TITLE **91-00-00-50B-61**
DUAL PEAK DETECTOR, SMT (1159965)

DWN	PJK	2/23/00	DWG. NO. 1159976	REV B0
CHK	LRT	2/26/01		
REL	LRT	2/26/01	B SCALE - - -	SHEET 1 OF 1

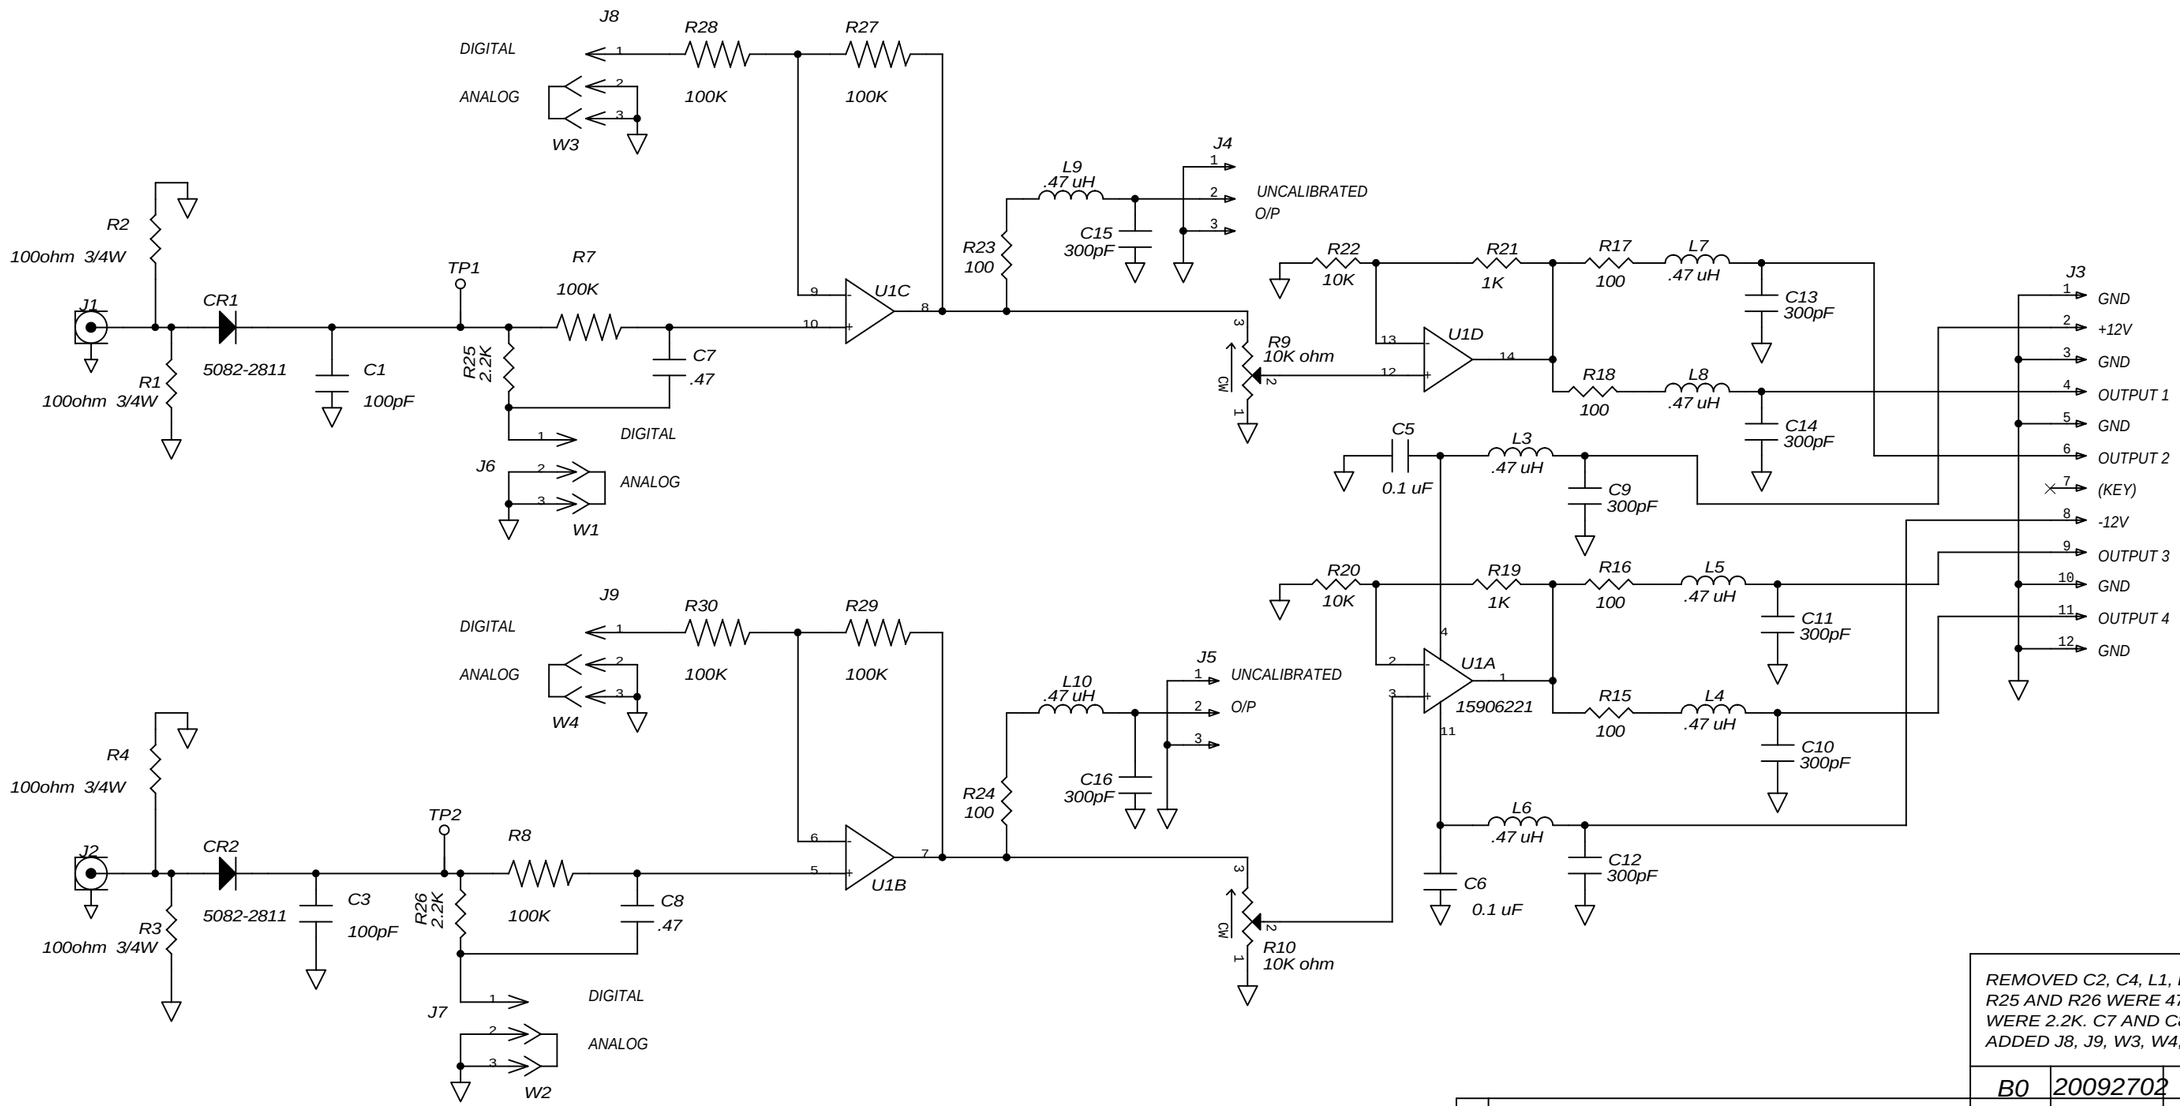
REMOVED C2, C4, L1, L2, CR3, AND CR4. R25 AND R26 WERE 470K. R7 AND R8 WERE 2.2K. C7 AND C8 WERE .001. ADDED J8, J9, W3, W4, R27-R30. (PJK)
